Application for Works Approval

Works Approval Number W3150/2025/1

Applicant Karora (Higginsville) Pty Ltd

Premises Higginsville Gold Project

Figure 2: Proposed Graveyard In-pit TSF, tailings delivery and return pipelines

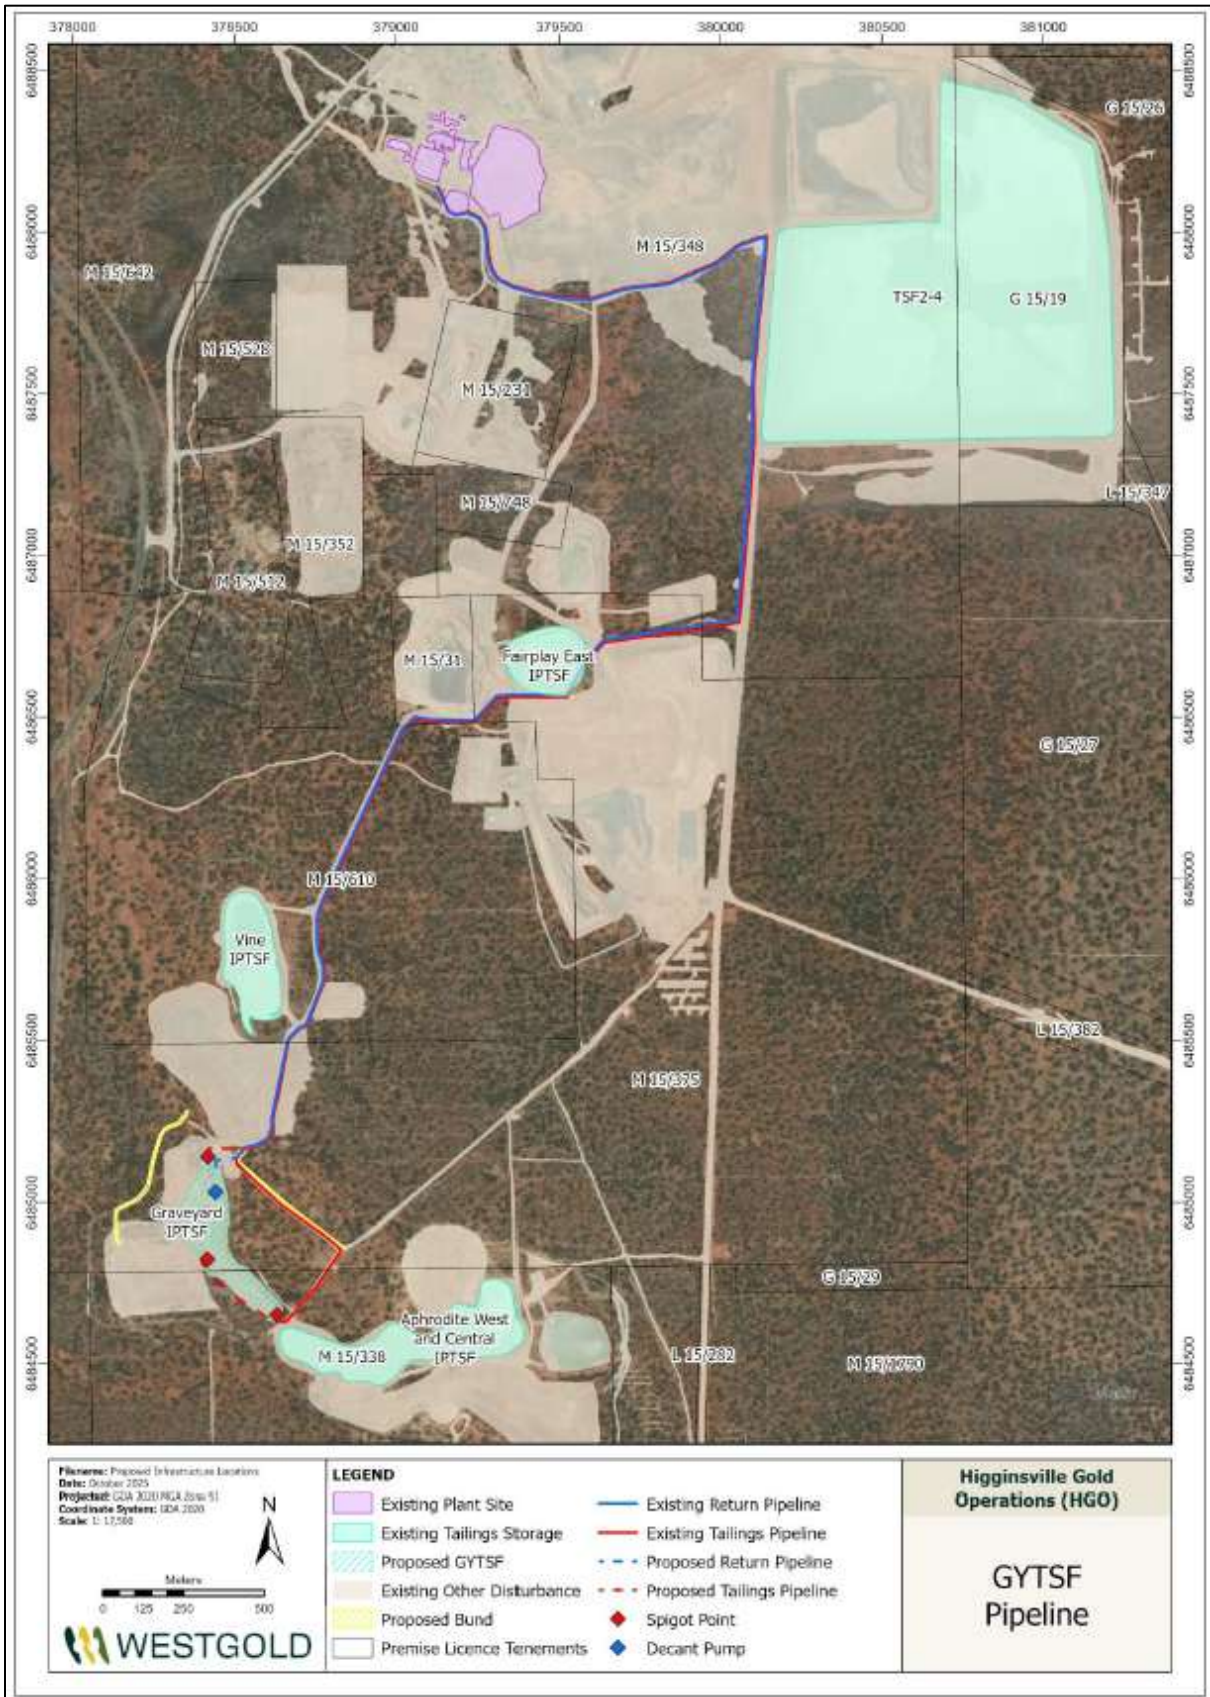
Summary of the comment	Department's response
<p><u>TSF design</u></p> <p>The pit sits in a palaeochannel with shallow groundwater, so even small seepage could allow contaminants to move into the surrounding aquifer. A groundwater-flow model using data from all existing and proposed bores is needed to assess how seepage might behave under worst-case conditions.</p>	<p>Risk events associated with seepage has been assessed in sections 3.2 and 3.3 of this decision report.</p>
<p><u>Seepage and Water balance Assumptions</u></p> <p>The Application assumes minimal infiltration and treats the pit as a closed basin, but evidence from nearby facilities shows groundwater mounding can rise over ten metres, potentially driving seepage toward the Graveyard Pit. A seepage-recovery program is recommended, including three additional downgradient bores about 200 m from the pit and monthly monitoring for WAD cyanide, total dissolved solids and major ions during the first two years.</p>
